Rezoning Transportation Analysis

Petition Number: 2023-046

Date	Description
08-25-23	First Review (NK)

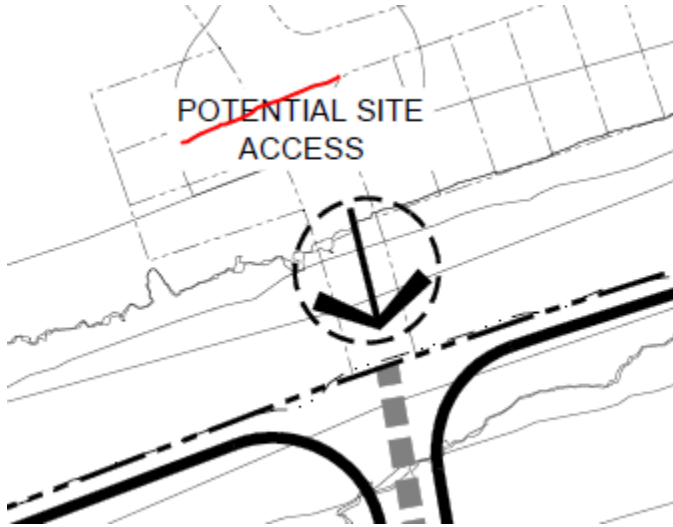
5. If abandonment required:
Add a conditional note specifying “The petitioner needs to complete and submit the [Right of way Abandonment Petition form](#) to CDOT for review. The Right of Way Abandonment process is controlled by North Carolina General Statutes and is independent of this rezoning process.”
6. Revise site plan to commit to removing the word potential from the access points as these are required connections.

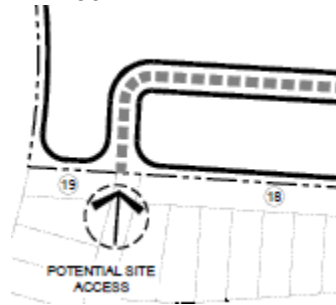
7. Remove this intersection, and ensure all future horizontal curves meet the minimum CDOT standard of 150' radius.

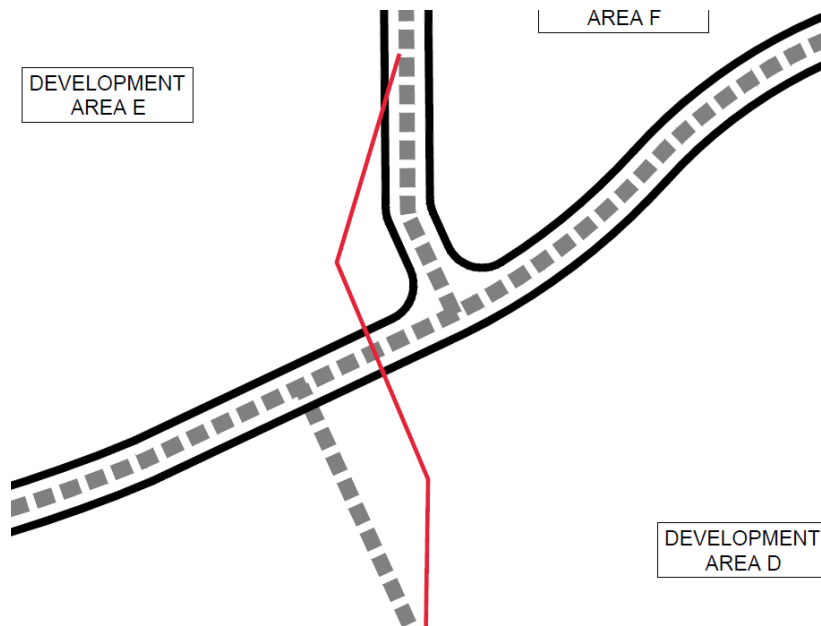
8. Align internal public roads to remove offset intersections.

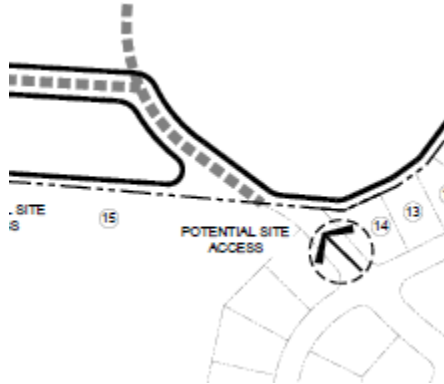
9. The horizontal curves pictured below need to have a minimum 50' separation to meet minimum CDOT standard.
